Application of Reginald Crayton to rezone property from RSM (Small Lot Residential Mix) zoning district to the R-85 (Residential Medium Lot-85) zoning district to allow the expansion of an existing place of worship, at 4710 Mandy Wicker Lane.

PETITION NO: N8-2026-1267 Z-26-1248271

Z-26-1248271 (2026-1267) Recommended Conditions
4710 Mandy Wicker Lane
November 2026

STAFF ANALYSIS

CONCEPTUAL SITE PLAN

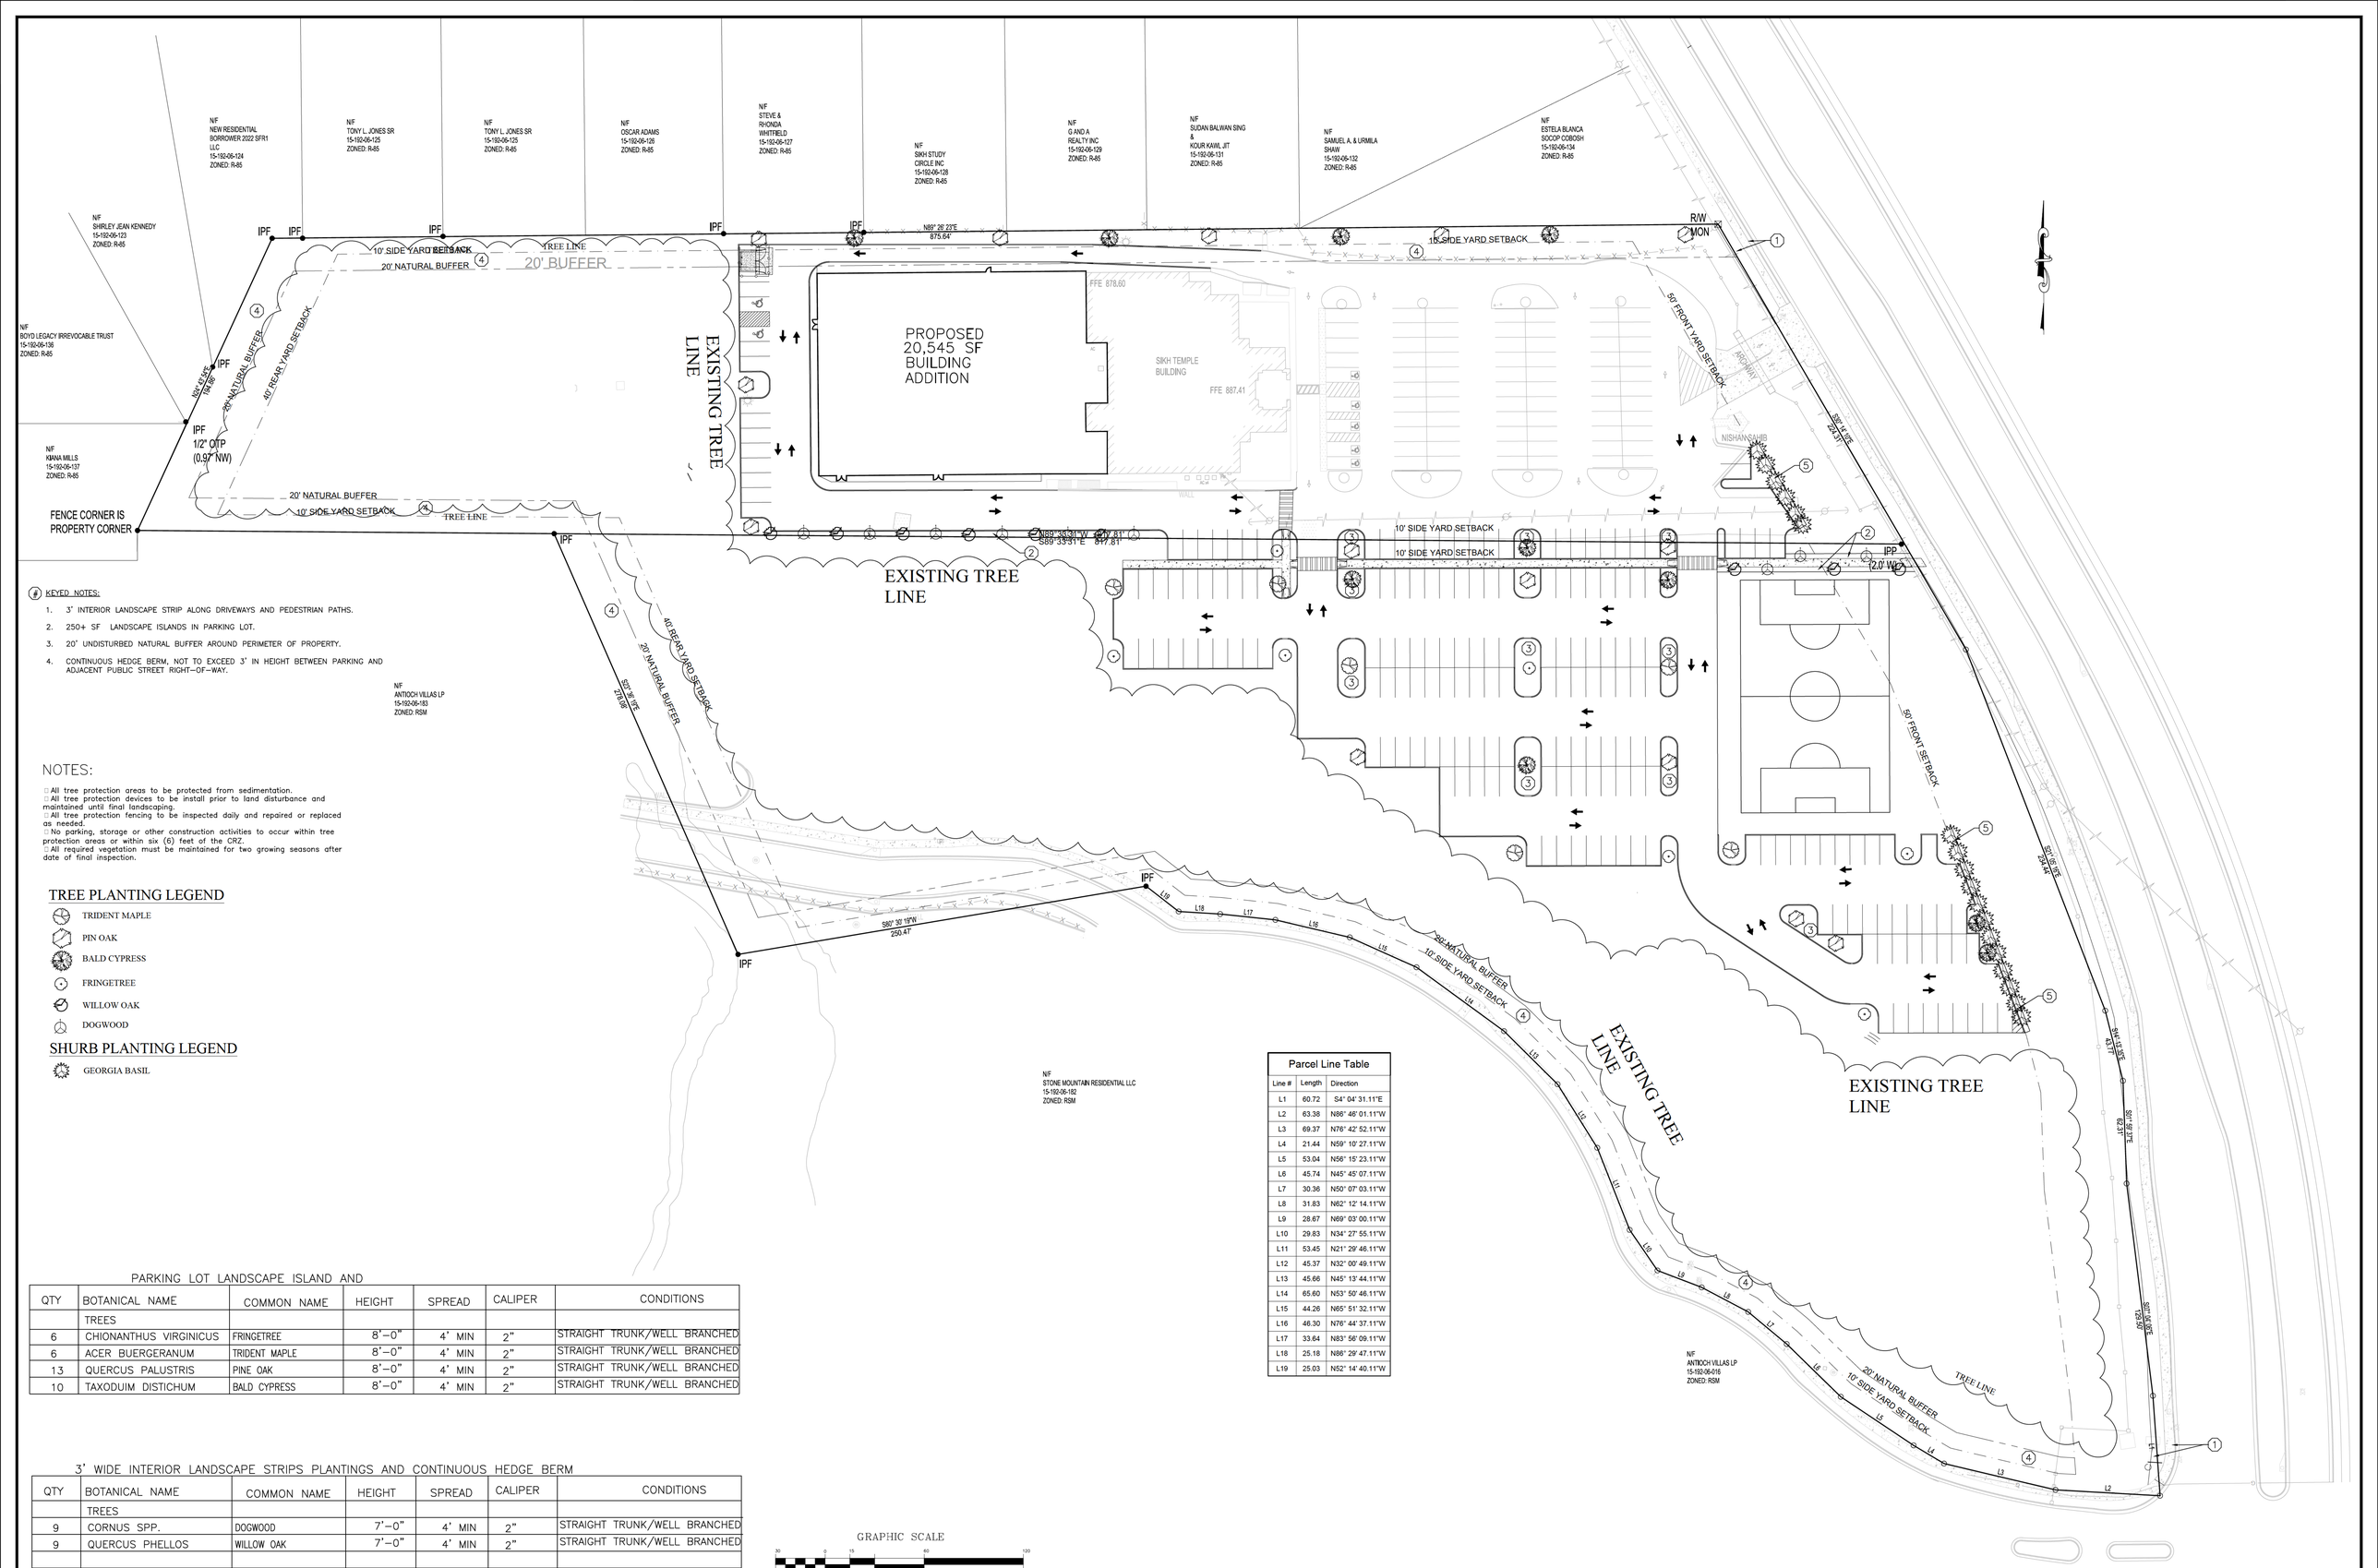
The plan labels an existing 11,708-square-foot building on the adjacent property to the north (1821 South Hairston), and a proposed 26,540-square-foot building, 218 total parking spaces, stormwater facilities, perimeter planting and a garden/walking trail on the subject property (4710 Mandy Wicker). The building labels total 38,248 square feet.

- **Stormwater Management:** Depending on the expansion a full stormwater design will be needed if over 5000 sqft

- **Flood Hazard Area/Wetlands:** Theres flooding on northwest side of the property at the property line

3. Before issuance of a land disturbance permit, the applicant shall obtain approval of a stormwater management plan addressing the northwest-boundary flooding, if applicable and applicable floodplain and drainage constraints, detention, water quality, and downstream effects. Any required frontage dedication and improvements shall be shown on the approved development plans following County confirmation of the affected public street frontage.

3. Before issuance of a land disturbance permit, the applicant shall obtain approval of a stormwater-management plan addressing the northwest-boundary flooding, if applicable and applicable floodplain and drainage constraints, detention, water quality, and downstream effects. Any required frontage dedication and improvements shall be shown on the approved development plans following County confirmation of the affected public street frontage.
